## Response to Action Item 3-74 Section 3.7

### SEB Issue List Regarding APR1400 DC FSAR 3.7

## APR1400 DCD TIER 2

Figure 1 Comparison of between CSDRS and FIRS (in-layer motion), E-W direction, 5% damping

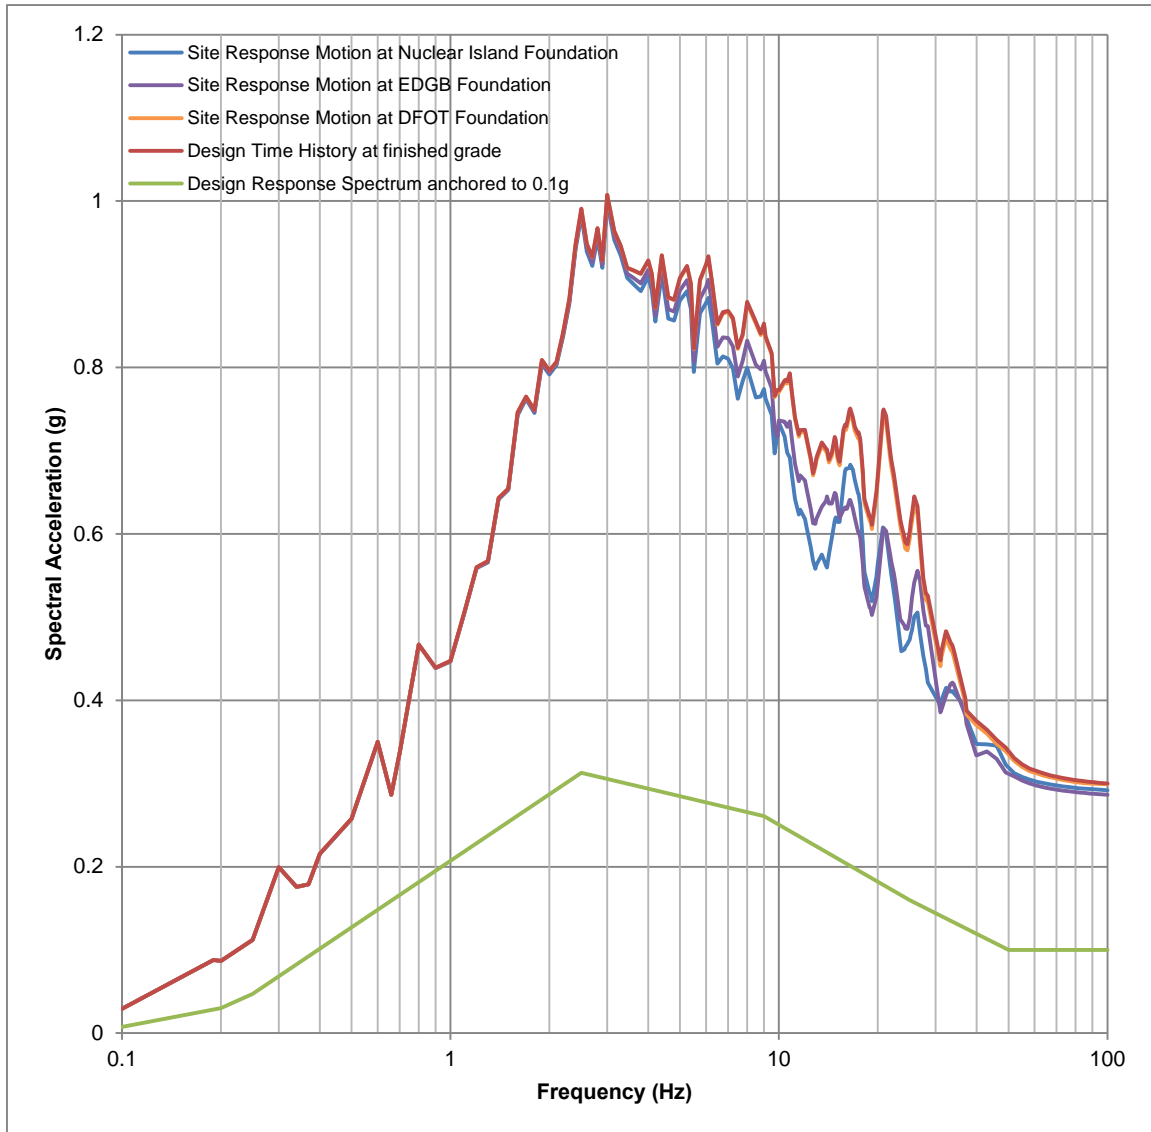
DCD Section 3.7.1.1.1 indicates that the horizontal components of the CSDRS in the free-field at the foundation level are in Figures 3.7A-12 and 3.7A-13. It is not immediately clear to the staff why the motion (spectral magnitude) at the surface is lower than the motion at depth. The general expectation is that the motion at the ground surface is higher than the motion at depth. As such, please explain why that does not occur in Figures 3.7A-12 and 3.7A-13.

The control point of the APR1400 CSDRS is the ground surface. If the FIRS is calculated by in-layer motion, spectral magnitude at surface and depth are consistent with the general expectation. For example, Figure 1 and Figure 2, using the SHAKE in-layer option, indicate that the motion at the ground surface is higher than the motion at depth, as expected. Figure 3 through Figure 8 show comparisons of the FIRS for the nuclear island (NI) building, the emergency diesel generator building (EDGB), and the diesel fuel oil tank (DFOT) for the nine generic soil columns.

Figure 3-24 Comparison of the Horizontal Target PSD Compatible with APR1400 HRHF Horizontal Response Spectra with the SRP 3.7.1 PSDs for CEUS Rock Sites

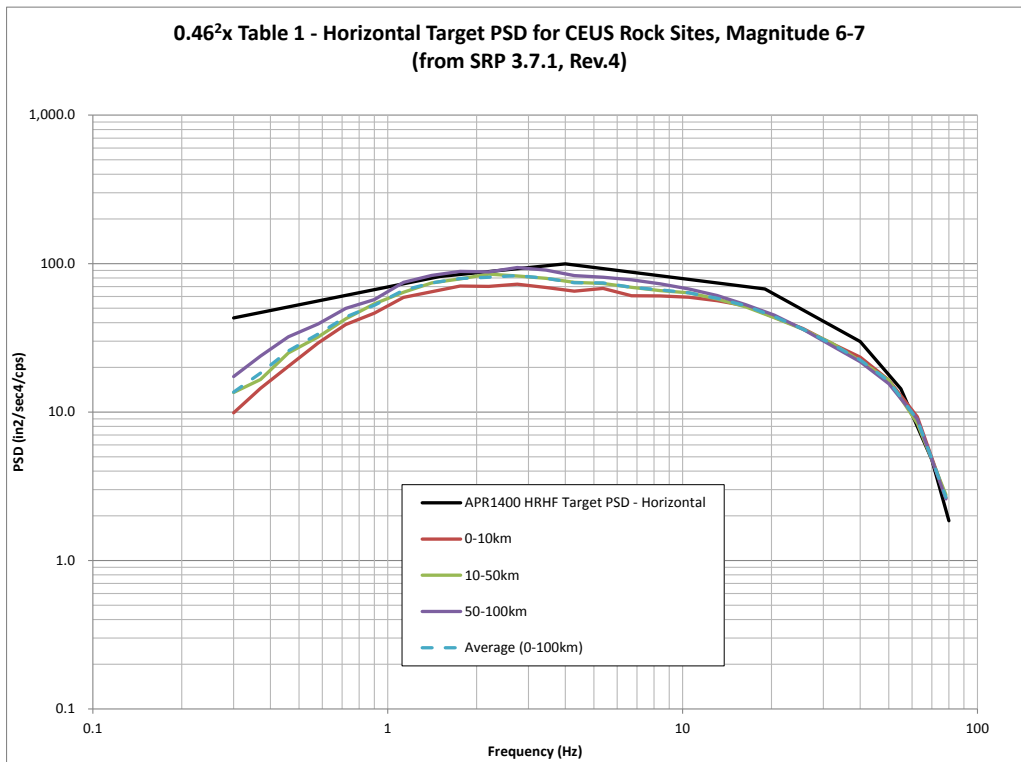
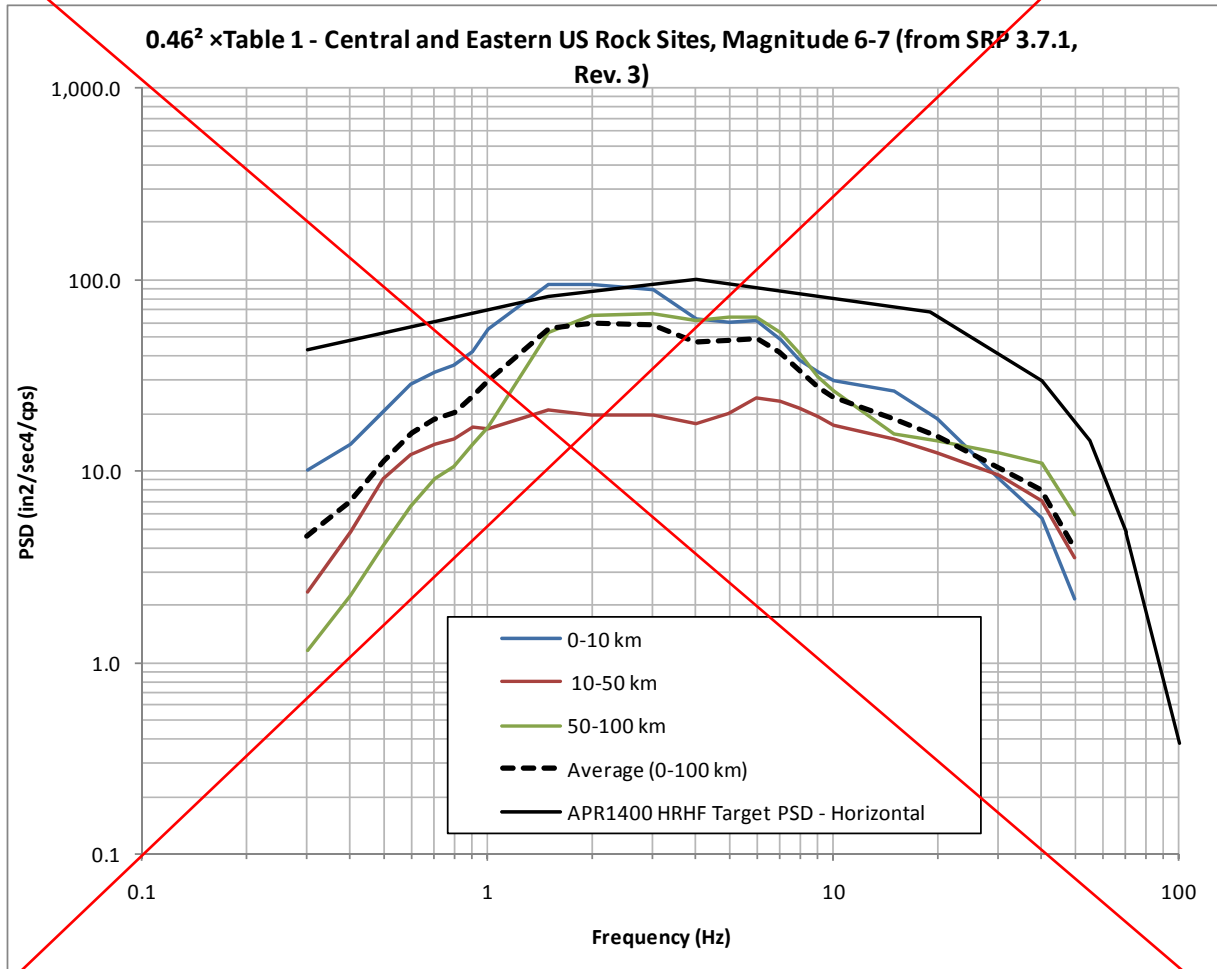
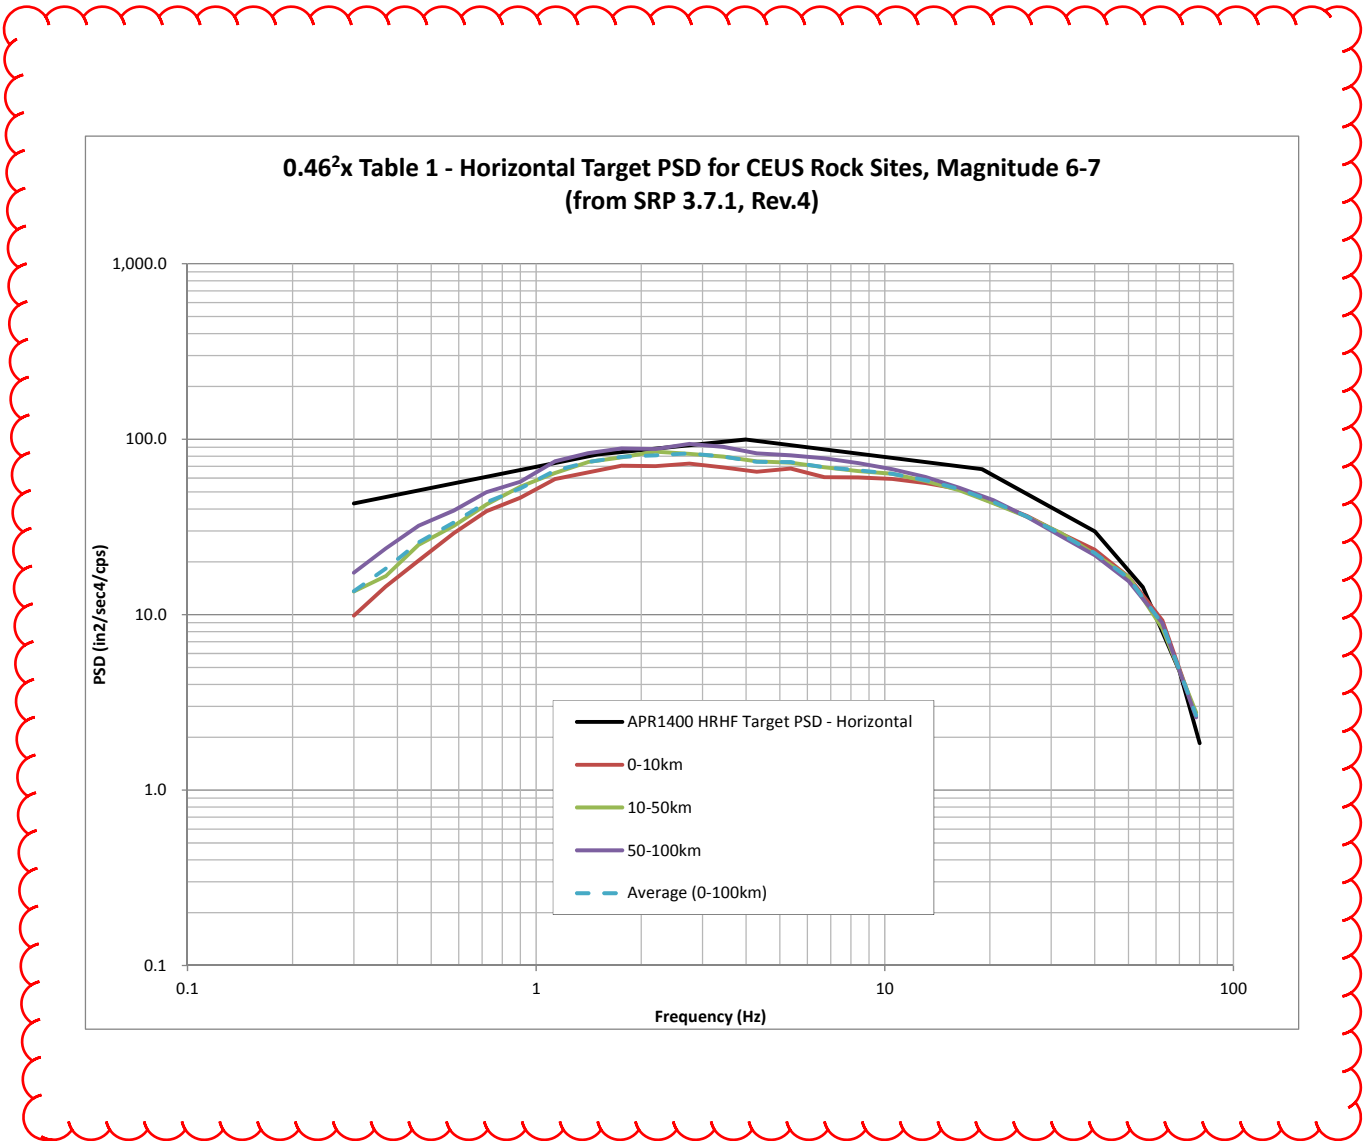
Section 3.5.1 of APR1400-E-S-NR-14004-P, Rev. 1, "Evaluation of Effects of [hard rock high frequency] HRHF Response Spectra on SSCs," compares the APR1400 HRHF horizontal target PSD with the target PSD curves presented in Appendix B of the SRP 3.7.1 Draft Rev. 4, as shown in Figure 3-24 of this report. The PSD tables in Appendix B of the SRP 3.7.1 Draft Rev. 4 were determined to have typos and those target PSDs are generally not compatible with the bin average response spectra. Appendix B of SRP 3.7.1 has been revised in Rev. 4 to address these issues and the guidance in SRP 3.7.1 has been updated. Therefore, comparison to the data in those tables in Appendix B of the SRP 3.7.1 Draft Rev. 4 is not considered to be appropriate and the HRHF report should be revised, as appropriate.

The PSDs presented in Appendix B of SRP 3.7.1 Draft Rev. 4 used for comparison with the APR1400 horizontal target PSD compatible with the HRHF horizontal DRS will be revised to the PSDs presented in Appendix B of SRP 3.7.1 Rev. 4, as shown in Figure 1. This revised figure of comparison will replace the corresponding figure in Section 3.5.1 of APR1400-E-S-NR-14004-P, Rev. 1.

Technical report, APR1400-E-S-NR-14004-P, Rev.1 Figure 3-24 will be revised as indicated in the attached markup
